SERVICE BULLETIN

NUMBER: 4-1304-A

SUBJECT: EXHAUST BULLETIN SUPPLEMENT 4-1304A

Exhaust and Breather system safety alert

Figure 5: Proper Installation of the CFR Exhaust

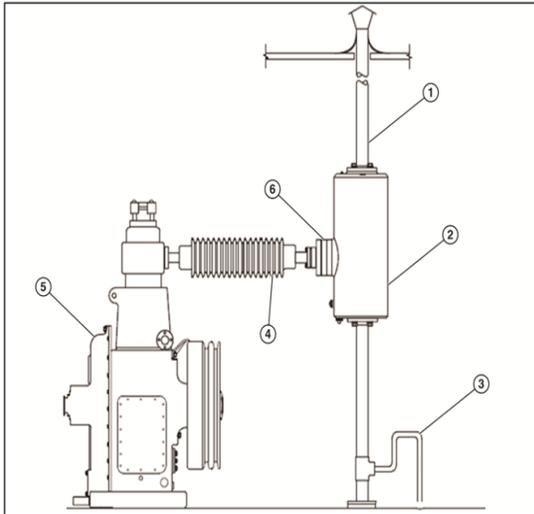
- If the exhaust stack is installed with a horizontal run through the side of a building structure to atmosphere, ensure that the vertical to horizontal transition is made with minimum amount of 45 degree elbows (suggested limit to no more than 2). A tight turn or a 90

degree elbow will result in a restriction which will affect breather and exhaust performance. A sweeping bend in the piping is acceptable, but care should be taken to inspect the pipe annually for any build-up of exhaust particulate that may cause blockage.

- If the unit is located in a climate where temperatures drops below 0°C (32°F) for extended time periods, it is highly suggested to plumb the breather exhaust vertically through the ceiling rather than through the wall. At freezing temperatures, exhaust condensate can build up inside the end of a horizontal pipe and freeze. This, in return, will create a blockage in the pipe resulting in excessive exhaust back pressure and potentially allow exhaust gases to get into the facility housing the unit. If you run your exhaust line horizontally, it is suggested to monitor back pressure on a regular basis. Back pressures levels indicated in the Operation and Maintenance manual (specific to each model) pertain only to the CFR surge tanks and exhaust assembly.

- The drain trap is recommended to be constructed of no more than 1 inch pipe with a sufficient height of at least 6 to 8 inches and a horizontal top length or at least 4 inches with a sufficient drop of piping to a floor drain. For further clarification from the previous bulletin, the drain pipe to the floor drain funnel or opening should be exposed to allow the operator to visually see the flow of the water in the system. Pipe larger than 1 inch can cause siphoning issues and may not allow the trap to be fully filled at all times to mitigate exhaust gases from entering the lab.
